**Re: APP/25/00162 At Land and coast adjacent to, Langstone Road,
Havant**

Flood and coastal erosion risk management scheme comprising a combination of raised earth embankments, raised footpaths/cycleways, sheet piled sea/flood defence walls with cladding and flood glass, provision of flood gates, associated landscaping and landscaping improvements (including street furniture), tree works and tree removals, realigned sections of cycleway/walkway, highway alterations and improvements, ecological improvements and temporary compounds and access, and all associated works. The proposal constitutes EIA development.

Thank you for your consultation on the above planning application. It is noted that the application constitutes EIA development and the Highway Authority have reviewed the documentation in so far as would be considered to be reasonably related to highway matters. The Planning Authority or the applicant should advise the Highway Authority if information falls in areas outside the below reviewed documents:

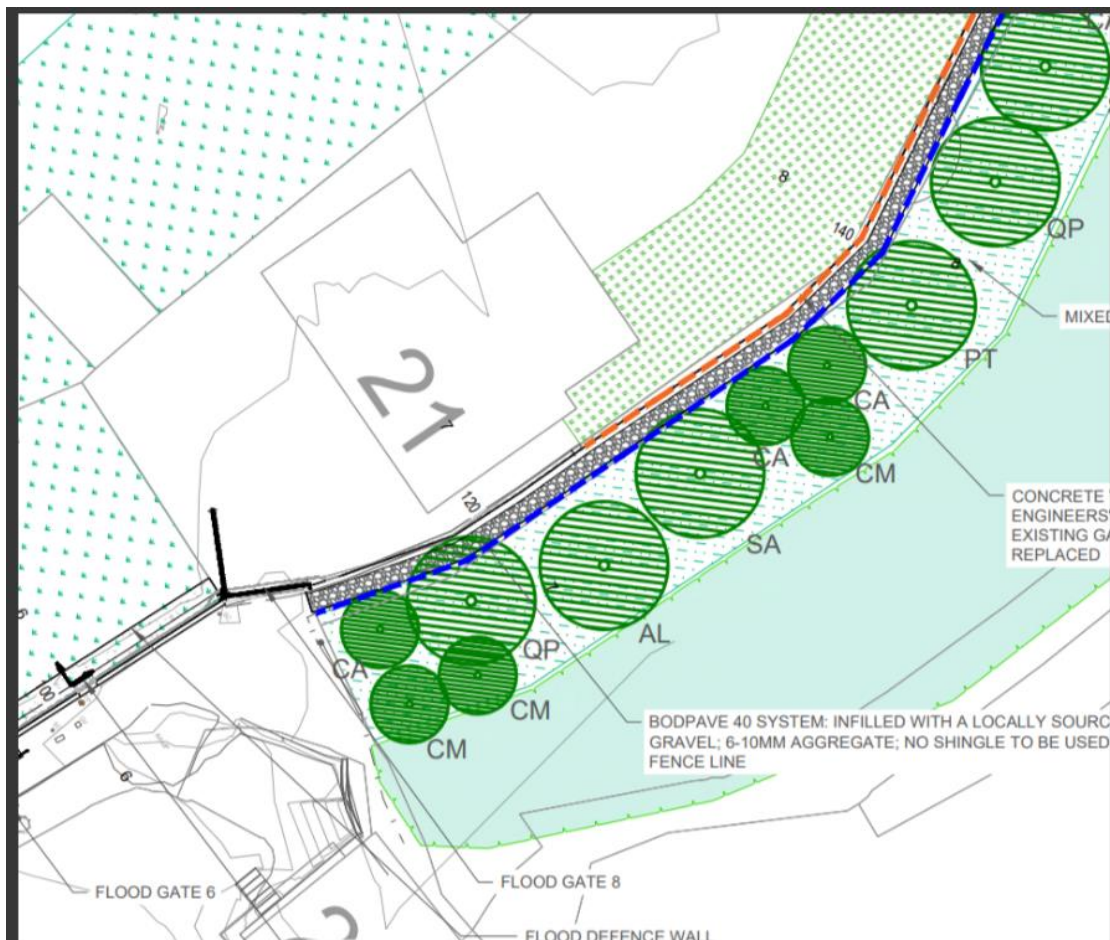
Voids in the existing structure have been noted previously through the design work and the Highway Authority have raised concerns regarding the treatment of these voids given the reduced ability for these to be addressed post these works. The Highway Authority consider that these voids remain a risk to the stability of the PRow and in addressing the deficits of the existing sea wall that supports the PRow network should address these voids. This can be addressed through the S278 process.

Outside number 21 High Street the sea defence appears to be being constructed on the footpath reducing its available width. A cross section should be provided setting out the details here and the useable width of the footpath that will remain. This is already a constrained section of the PRow network, and the width of the PRow should be protected through the design.
